MECKLENBURG COUNTY
DEPARTMENT OF ENVIRONMENTAL HEALTH

SITE EVALUATION

Reference: Property located at 4425 Garvin Drive

LOW PRESSURE SYSTEM INSTALLTION WORKSHEET

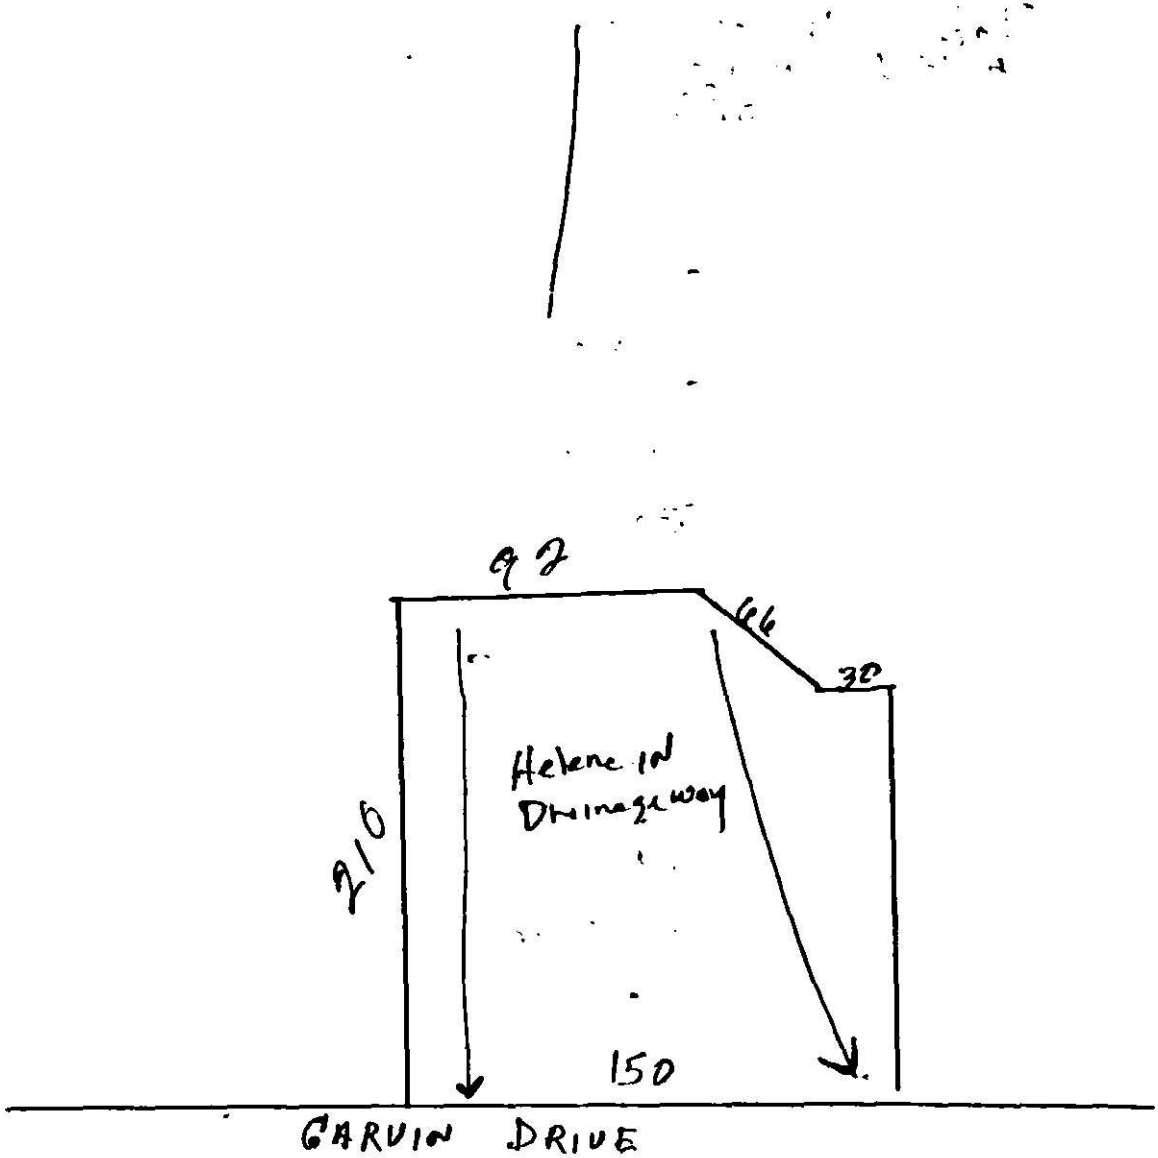
FACTORS	AREA 1	AREA 2	AREA 3	AREA 4
1. SLOPE (%)	S (PS) 2-6 U	S PS U	S PS U	S PS U
2. SOIL TEXTURE (12-36 inches) Sandy, Loamy, Clayey (Note 2-1 Clay)	S mixed PS (U)	S PS U	S PS U	S PS U
3. SOIL STRUCTURE (12-36 inches)	S Weak PS Blocky (U)	S PS U	S PS U	S PS U
4. SOIL DEPTH (inches)	S (PS) 30-45 U	S PS U	S PS U	S PS U
5. RESTRICTIVE HORIZONS (Inches) (Impervious strata, Rock)	S (PS) None U	S PS U	S PS U	S PS U
6. SOIL DRAINAGE/GROUNDWATER (external and internal)	S PS Slow U	S PS U	S PS U	S PS U
7. OTHER (Specify)	S IN PS Drainage U Way	S PS U	S PS U	S PS U
8. SOIL GROUP	II.L			
9. SITE CLASSIFICATION	Unsuitable			
10. SOIL SERIES	Helena

Recommendations/Comments:

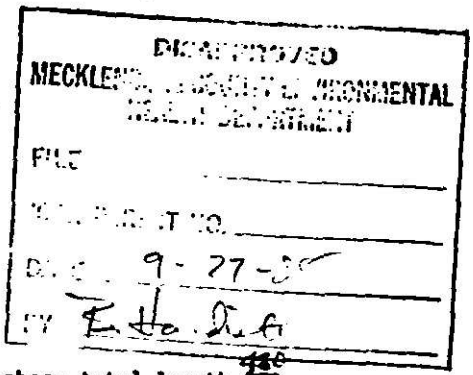
1) The effluent loading rate utilized for design of the system was 0.15 gpd/ft^2. This rate is applicable for some provisionally suitable soils. Soils on the site were classified unsuitable.

2) The soil structure and texture on the site were classified unsuitable. Such sites are not suitable for LPP installation.

3) Substantiating data has not been provided to indicate the proposed system would: a) properly treat the effluent, b) not allow effluent to contaminate any surface-or ground-water supplies or c) not be exposed on the ground surface.

Based upon these findings, the plan as submitted has been disapproved.
